Groundwater Remedy Construction, PG&E Topock Compressor Station, Needles, California

Work Variance Request #10 – Revised Alignment for Pipelines C18 (East Ravine) and I1 (Bat Cave Wash), and Consolidation of Pipes/Conduits in the Southernmost Area of TCS

Date Submitted: 12/1/21

Variance Request No.: 10

Proposed Changes in Pipeline Alignment

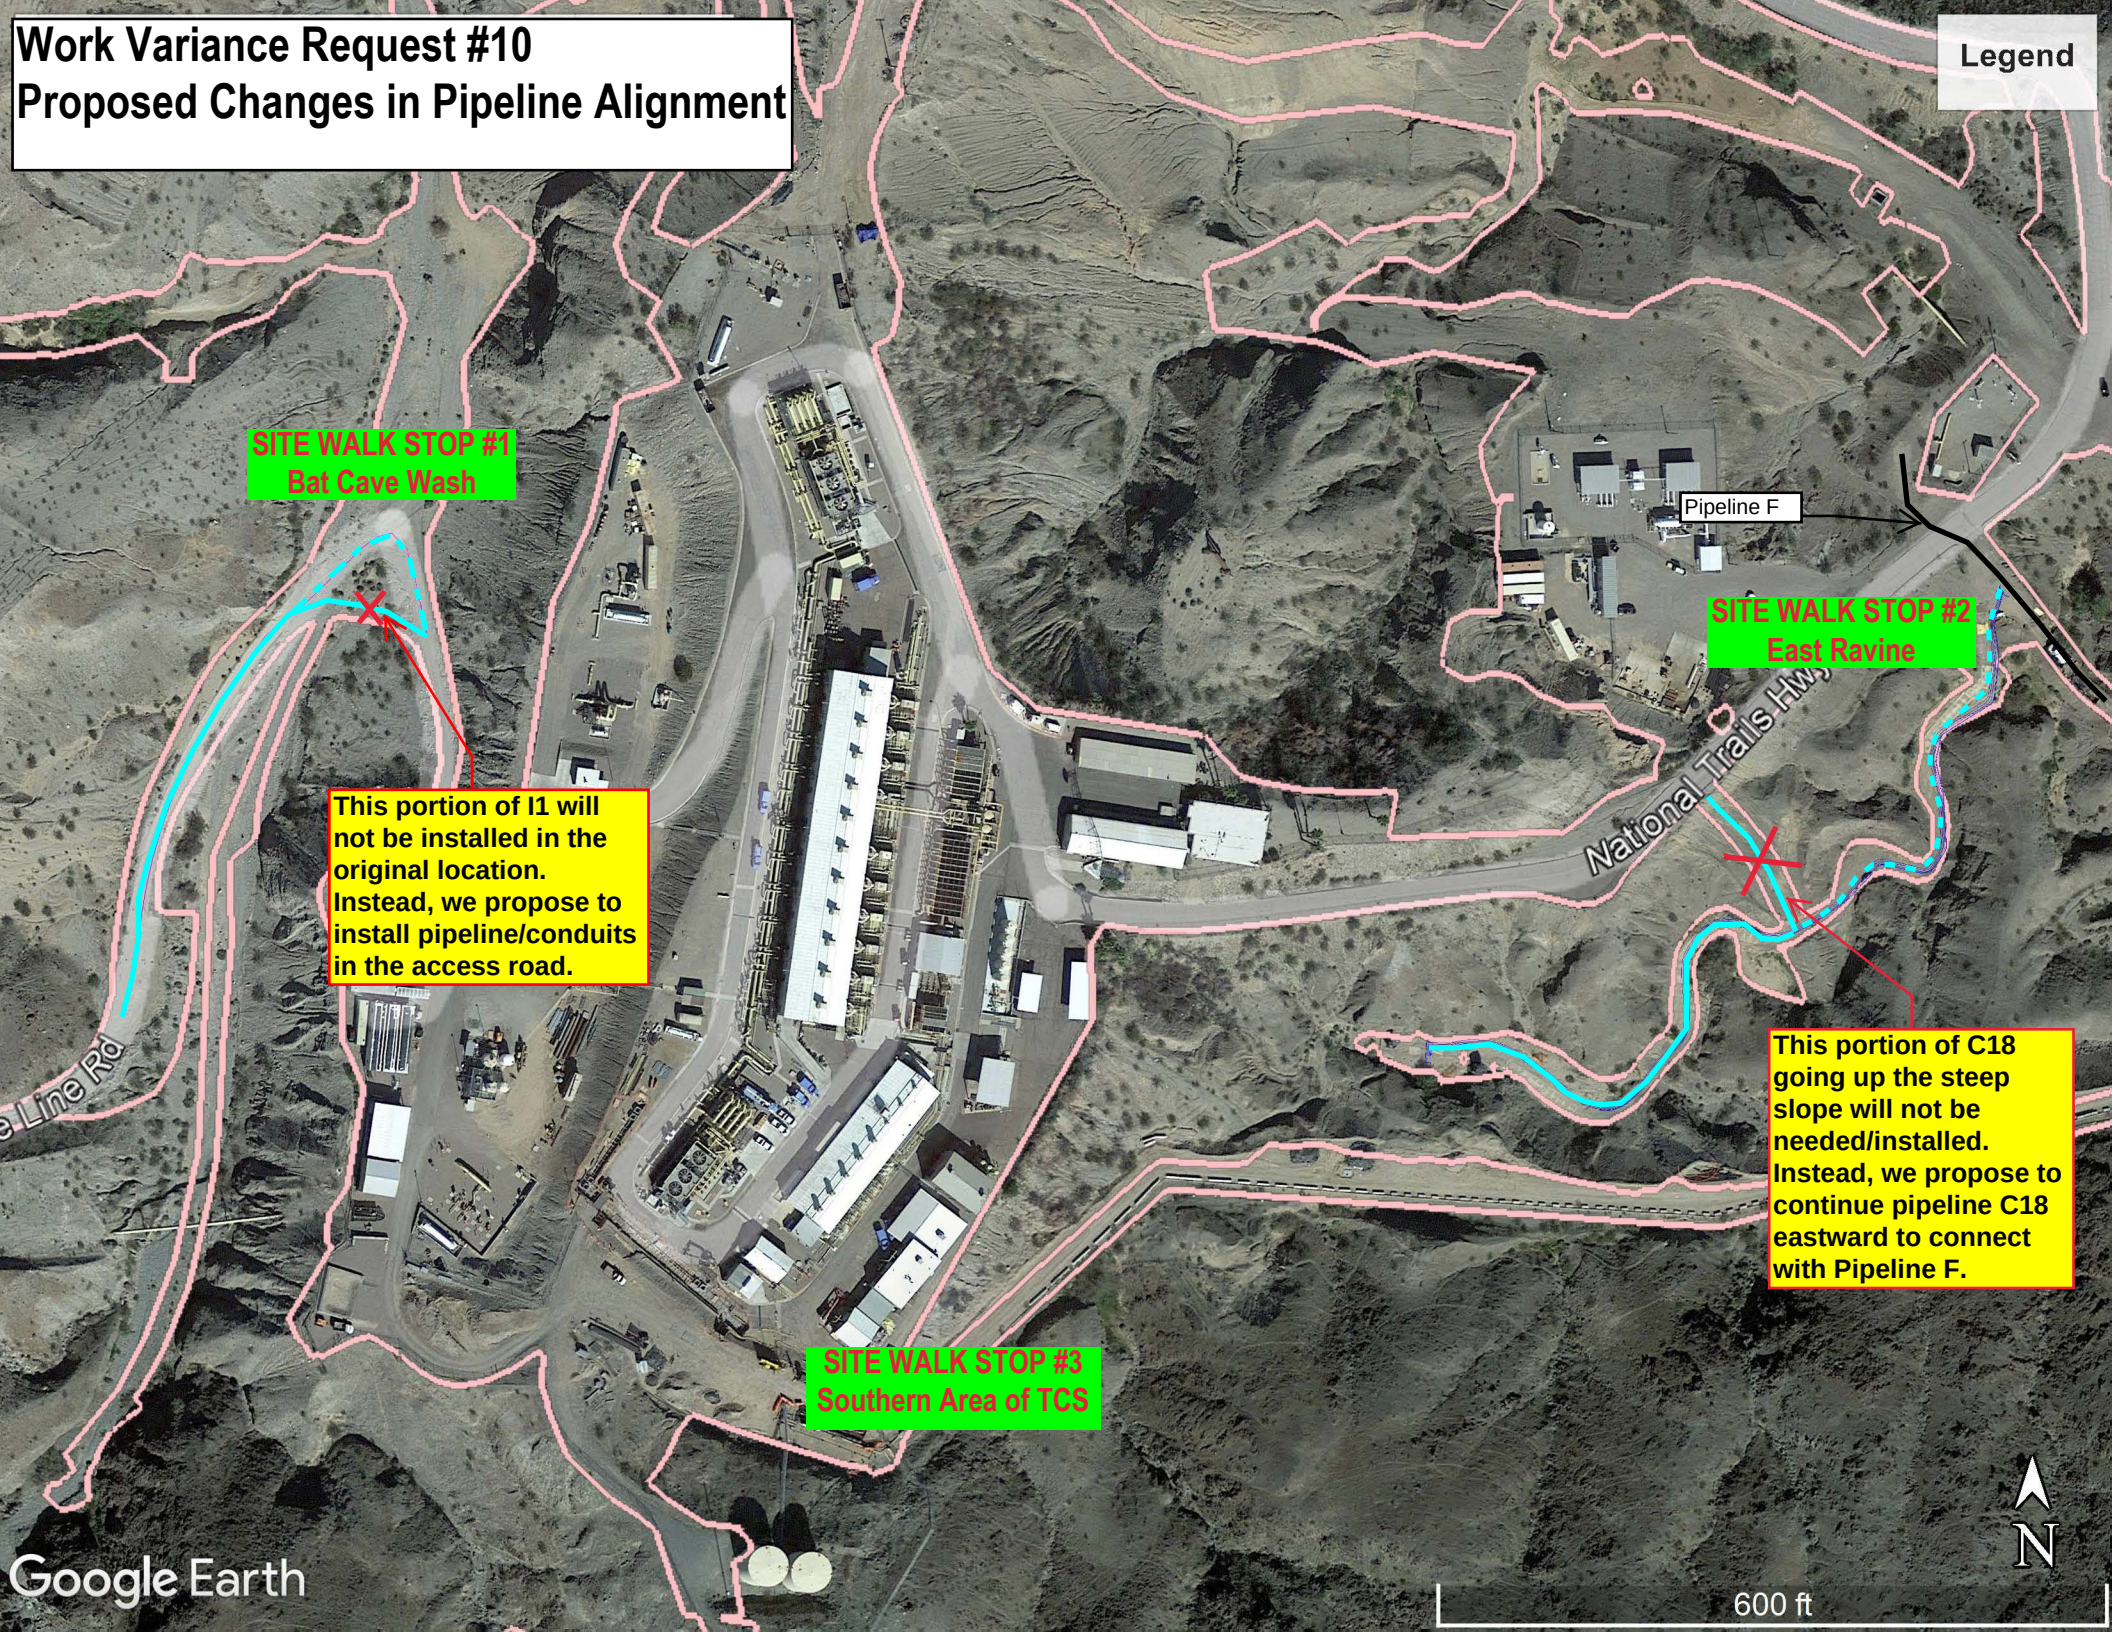
This portion of I1 will not be installed in the original location. Instead, we propose to install pipeline/conduits in the access road.

This portion of C18 going up the steep slope will not be needed/installed. Instead, we propose to continue pipeline C18 eastward to connect with Pipeline F.
